### CHANGE PROPOSAL

**CP Number:** 08R2 **RFP #:** CPR 03

Project: Galveston ISD Weis Middle School Ph 1 Renovation

Description: Central Middle School restrooms 135 & 137 remodel. Excludes Boys restroom by SPED. Excludes HVAC controls Excludes Terrazo floor repair in corridor at Rm 137

ABELING/OCR:	BING UNDERFLOOR PLAN			
File Path: Autodesk Docs://Galveston ISD_220431_Central MS/P23_220431 GISD Central MS.rvt				4" 5
CHEC Check DRAW Author Plot S	/N BY:	1	<b>1ST F</b> SCALE: 1"

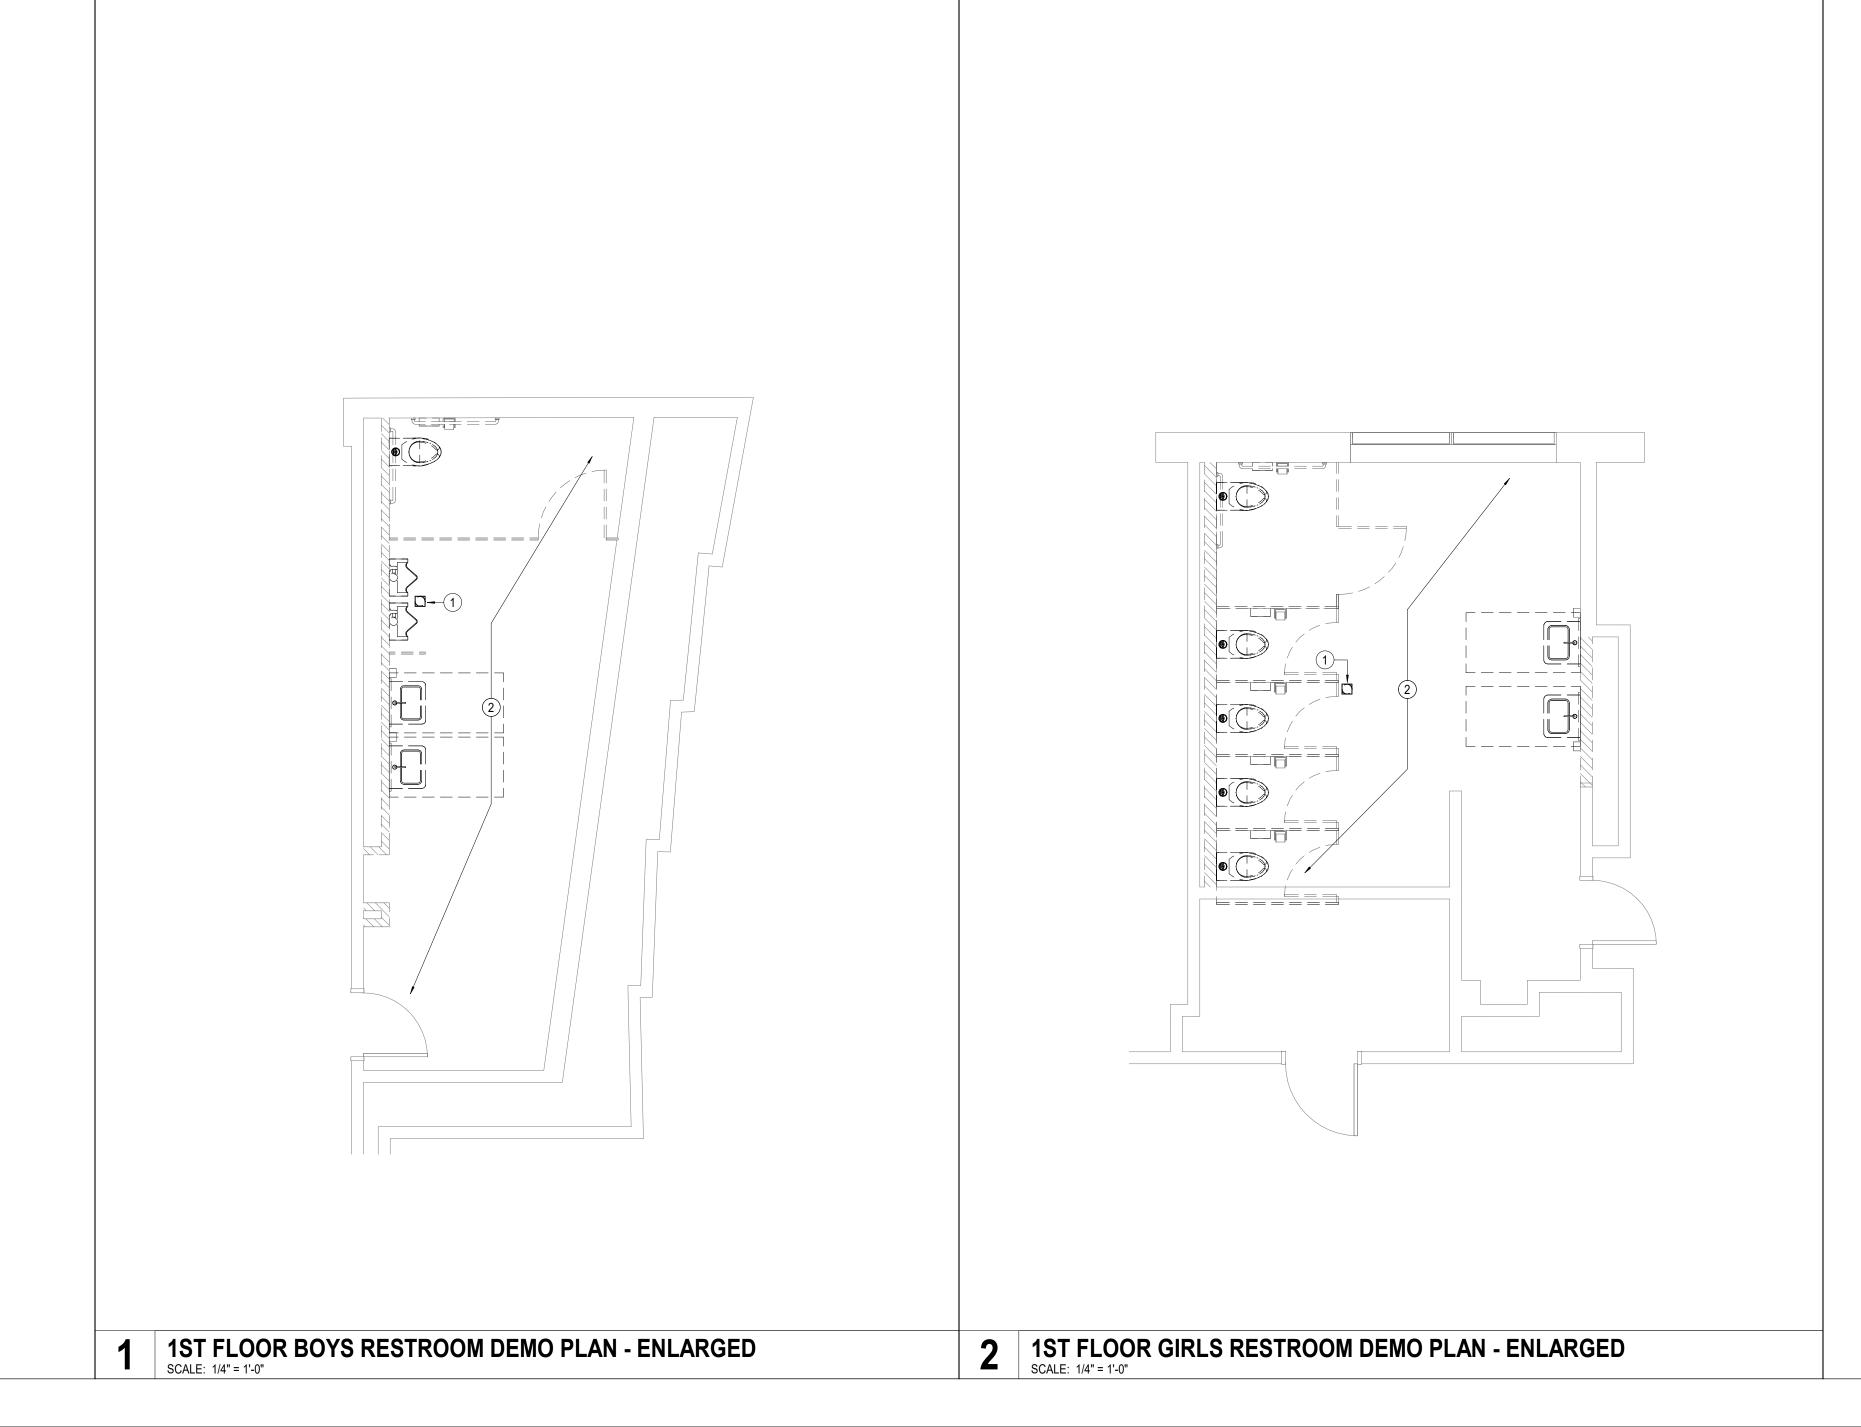
- 1 DEMO, REMOVE, REPLACE & RELOCATE EXISTING FLOOR DRAIN TO ACCOMMODATE FOR NEW CHASE SPACING. CONTRACTOR SHALL SAWCUT & PATCH/REPAIR EXISTING SLAB TO MATCH EXISTING CONDITION AS REQUIRED. CONTRACTORS SHALL FIELD VERIFY EXISTING CONDITIONS PRIOR TO COMMENCING ANY WORK.
- 2 DEMO, REMOVE AND REPLACE EXISTING PLUMBING FIXTURES. CONTRACTOR SHALL PATCH AND REPAIR ALL WALLS AFTER DEMO AND INSTALLATION TO MATCH EXISTING CONDITION AS REQUIRED. CONTRACTOR SHALL FIELD VERIFY EXISTING CONDITIONS PRIOR TO COMMENCING ANY WORK. EXISTING FLOOR DRAIN(S) TO REMAIN, RELOCATE AND BE PROTECTED DURING CONSTRUCTION. RE: NEW CONSTRUCTION DRAWINGS FOR FIXTURE SCHEDULE.

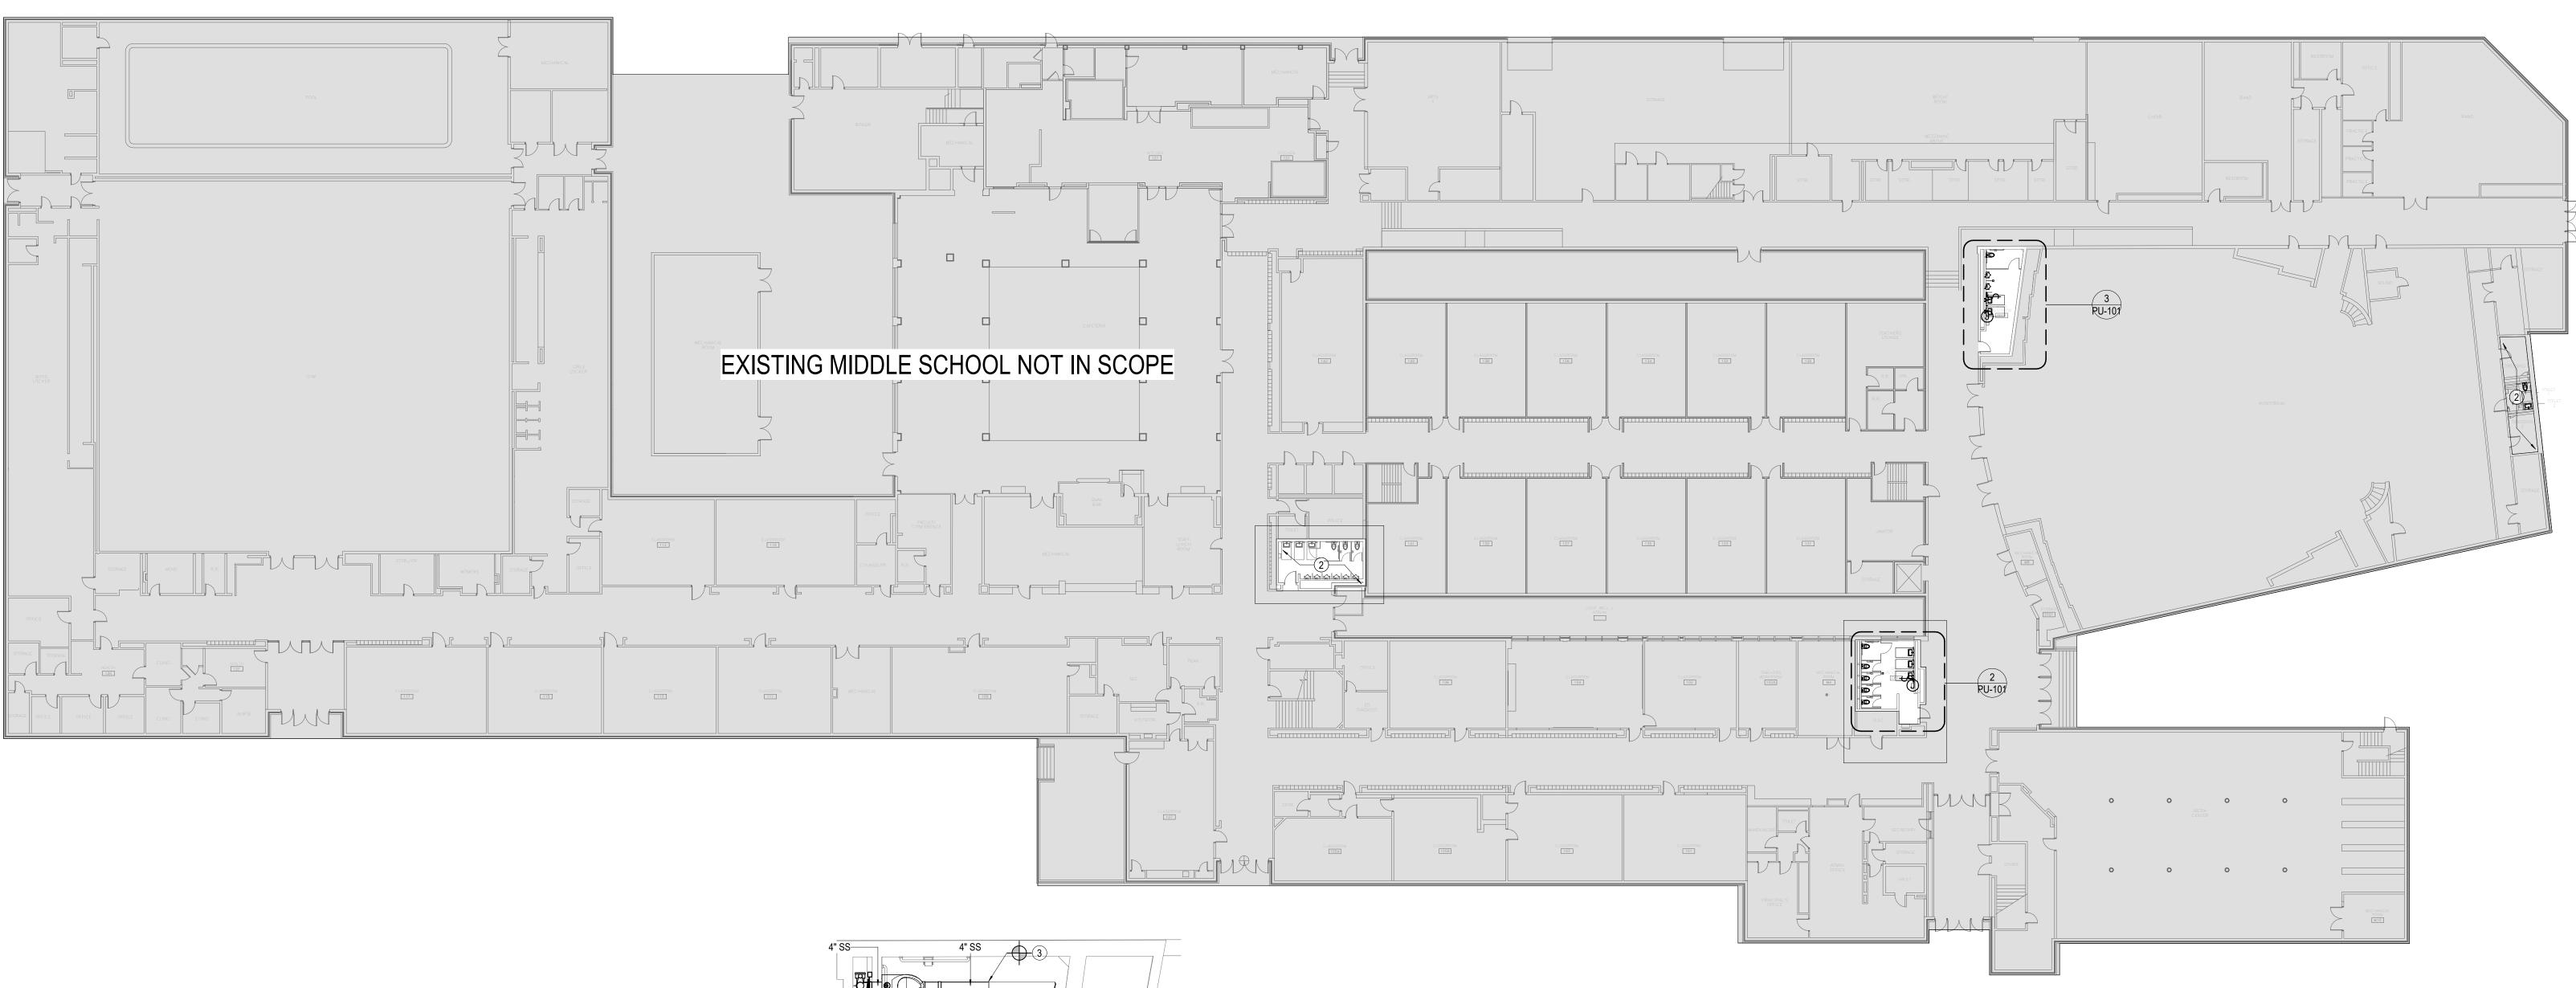
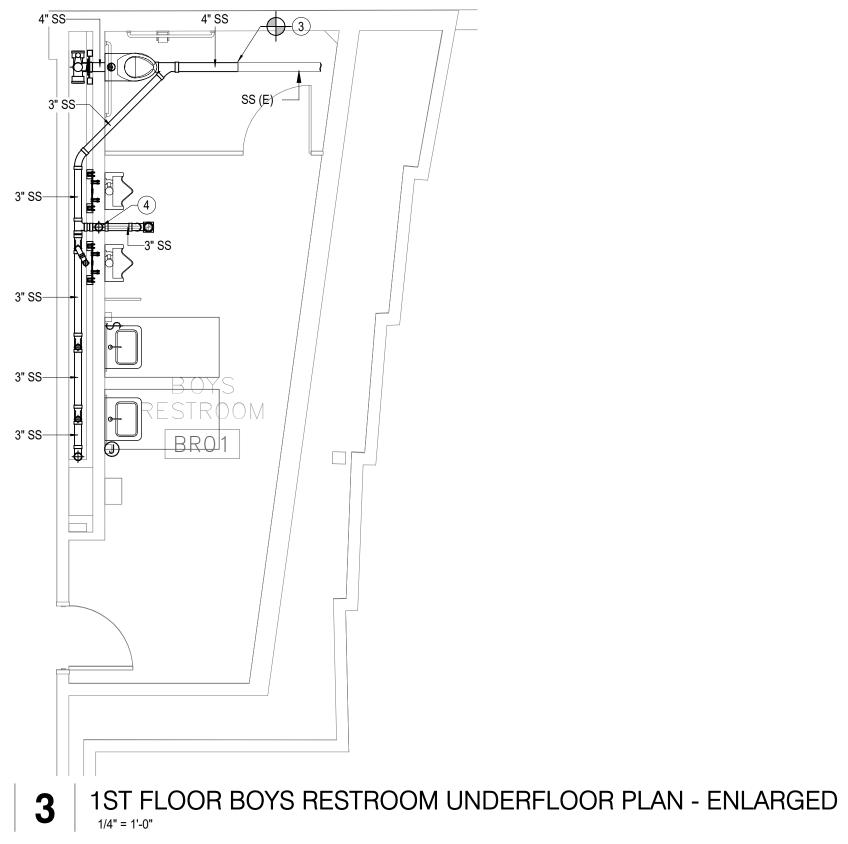
- 1 3" WASTE DOWN, 2" VENT-UP.
- 2 NO NEW PLUMBING SCOPE.
- 3 CONNECT NEW 4" SANITARY PIPING TO THE NEAREST 4" SANITARY LINE. CONTRACTOR SHALL SAWCUT & PATCH/REPAIR EXISTING SLAB TO MATCH EXISTING CONDITION AS REQUIRED. CONTRACTOR SHALL FIELD VERIFY AND LOCATE EXISTING
- 4 3" VENT UP.

# EXISTING MIDDLE SCHOOL NOT IN SCOPE

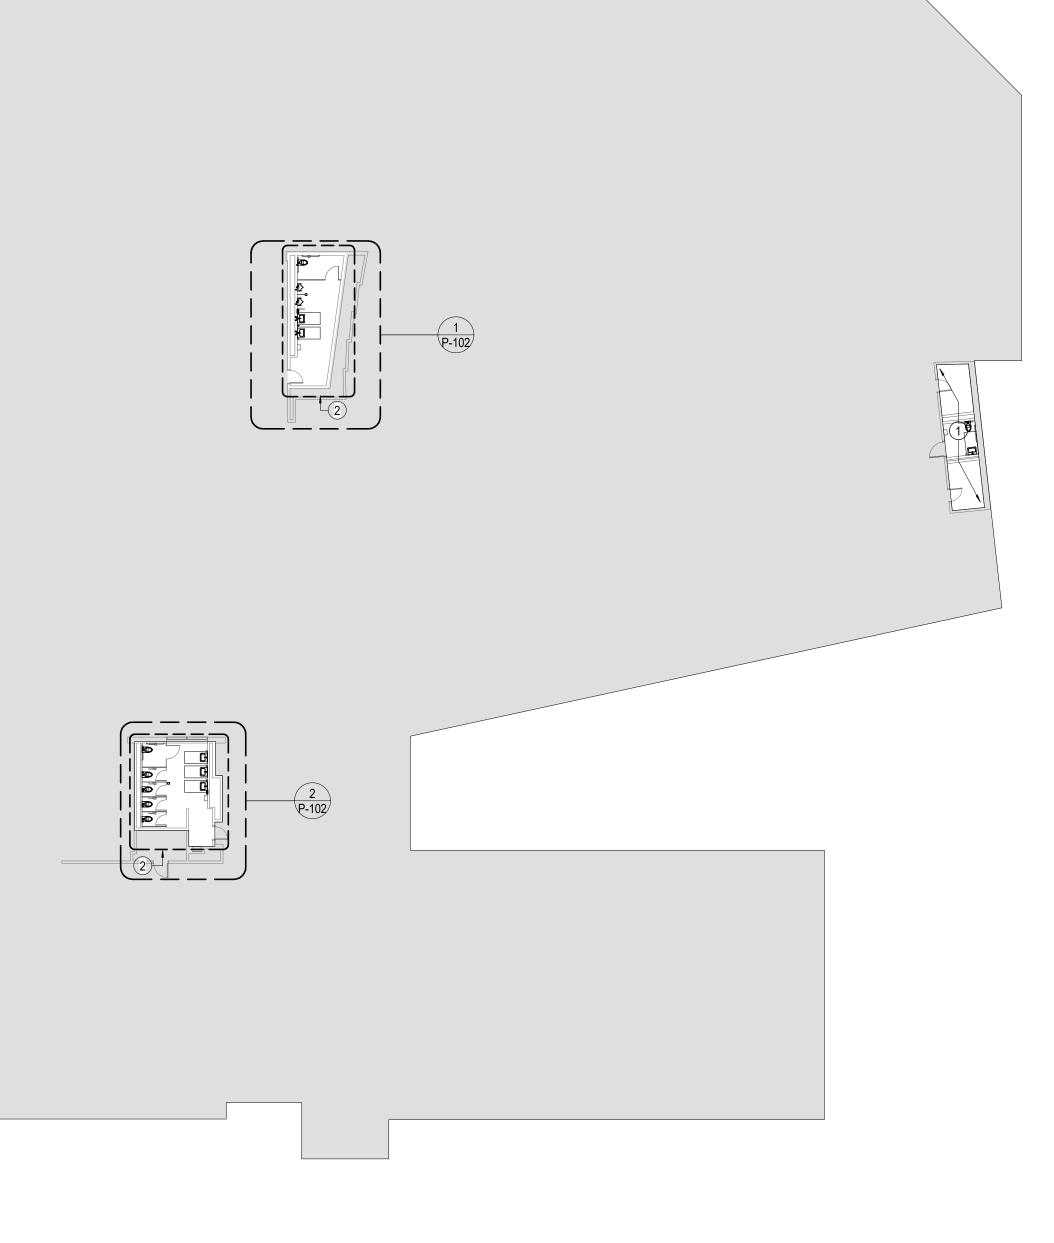
- 1 NO NEW PLUMBING SCOPE.
- 2 REWORK EXISTING SPRINKLER HEADS IN THIS AREA TO MATCH NEW CEILING LAYOUT.
